Serial No. 10/066,764  
Reply dated **February 11, 2004**  
In Response to Office Action dated October 17, 2003

Docket No. K-0392

### **REMARKS**

FIG. 4

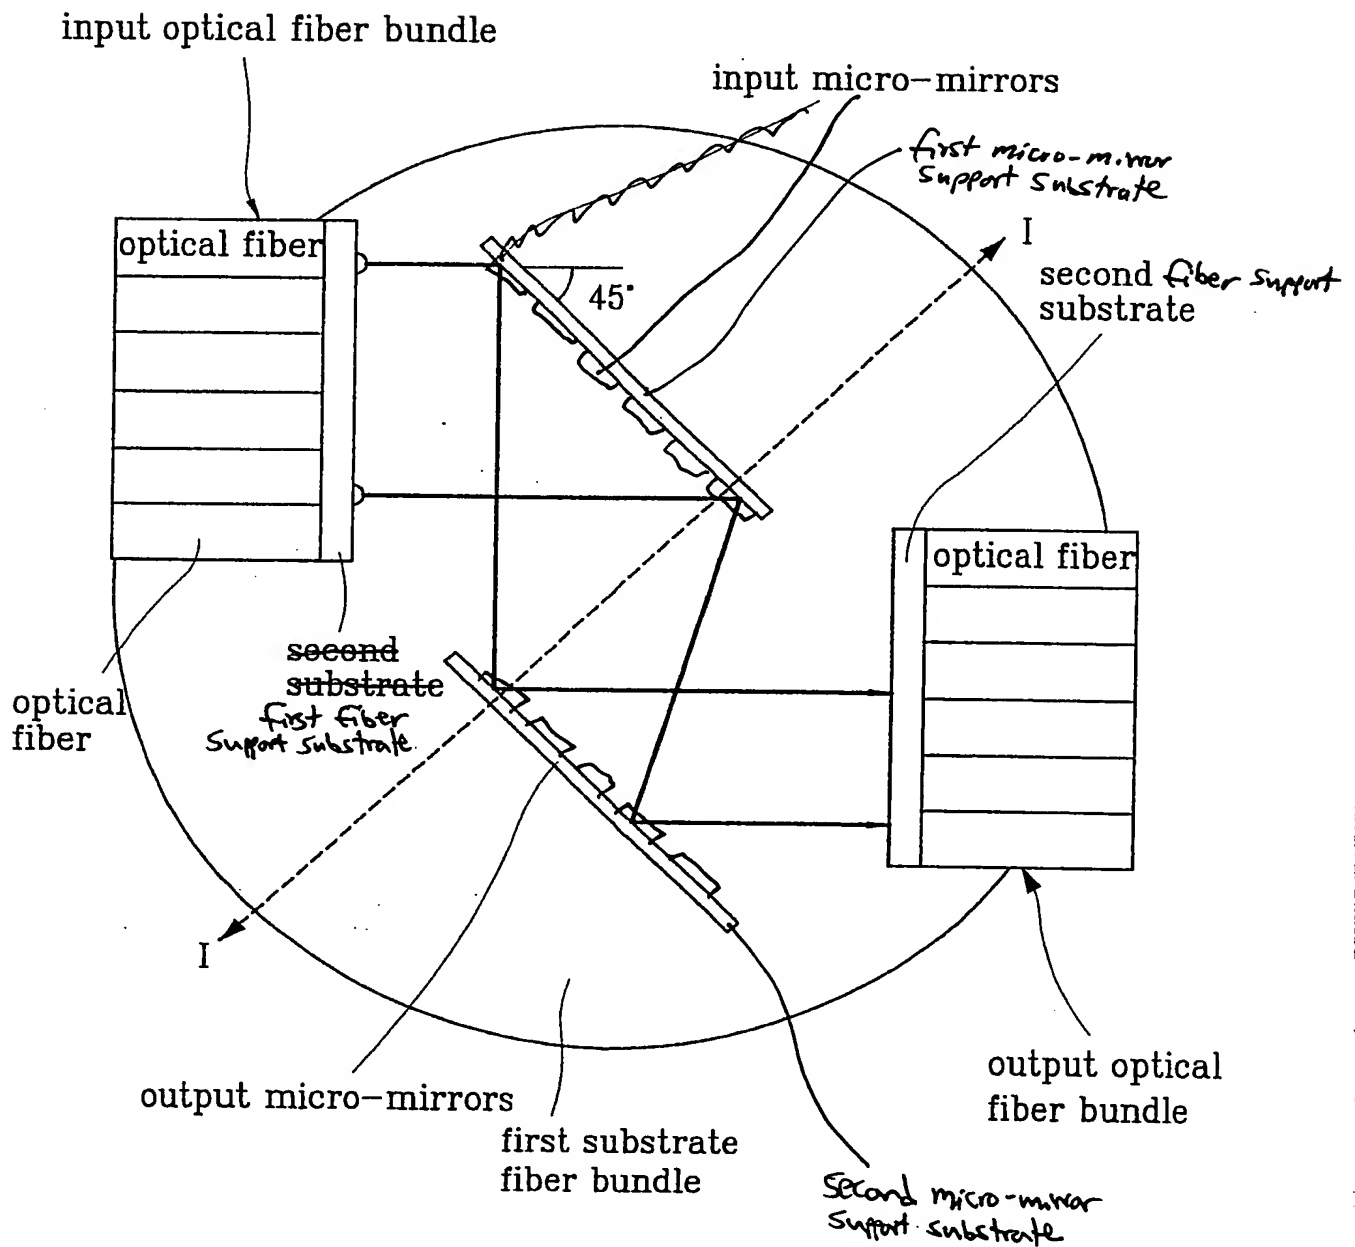
The Office Action objects to the drawings under 37 C.F.R. 1.83a because the drawings allegedly do not show every feature of the invention specified in the claims. Figs. 4 and 7 have been amended, as shown in the attached replacement sheets, to add labels for the first and the second fiber support substrates and first and second micro-mirror support substrates. In addition, the specification has been amended to conform to the drawings. No new matter has been added.

Claims 1-7 and 9-11 are pending in this application. By this Amendment, claims 1, 2, 4, 6 and 9 are amended, and claim 8 is canceled without prejudice or disclaimer of the subject matter therein. In addition, Figs. 4 and 7 have been amended to correct informalities. Replacement sheets that include corrected Figs. 4 and 7 are attached.
